**Applicant:** Oliver Denzler  
**Application No.:** 10/590,007

**REMARKS**

attachment surface of the contoured outflow end side is clearly shown in Fig. 9 of the application, reproduced below.

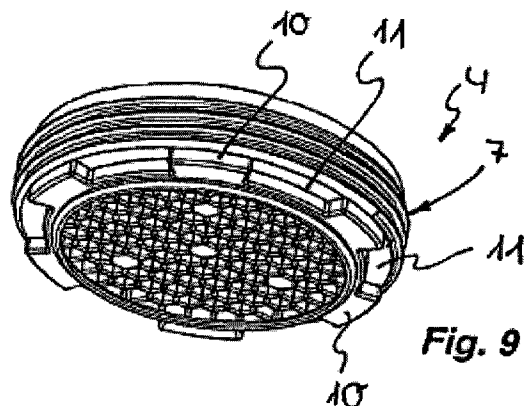
Claim 1 has been amended to include the limitations of claim 4 which was not rejected under §102 thus rendering the rejection moot. Regarding claim 10, the '093 patent fails to teach a spout device including a mounting sleeve having an external thread, which is connected to a water spout, having an internal tread, of a plumbing water spout fitment via a screw connection. A jet-regulating device, with an attachment screen is connected upstream of the jet-regulating device in a direction of flow. The jet-regulating device is provided as a perforated plate and has a perforated area at least in a partial region thereof. An outflow-side jet-regulating device is arranged on a spout-side sleeve end region of the mounting sleeve and the jet-regulating device is formed in one piece on the mounting sleeve. The spout device (4) has a contoured outer outline and/or a contoured outflow end side tool attachment surface for a tool insert as is currently claimed in claim 1. The tool

As mentioned in the specification at paragraph [0054], the spout device 4 shown in Figs. 7 to 9 has a contoured outflow end side, which has contouring formed from end-edge projections 10 and recesses 11. This contouring formed by the projections 10 and the recesses 11 can be used as a tool attachment surface for the complementary recesses and projections of a tool insert. There is no tool attachment surface shown in the '093 patent as is currently claimed.
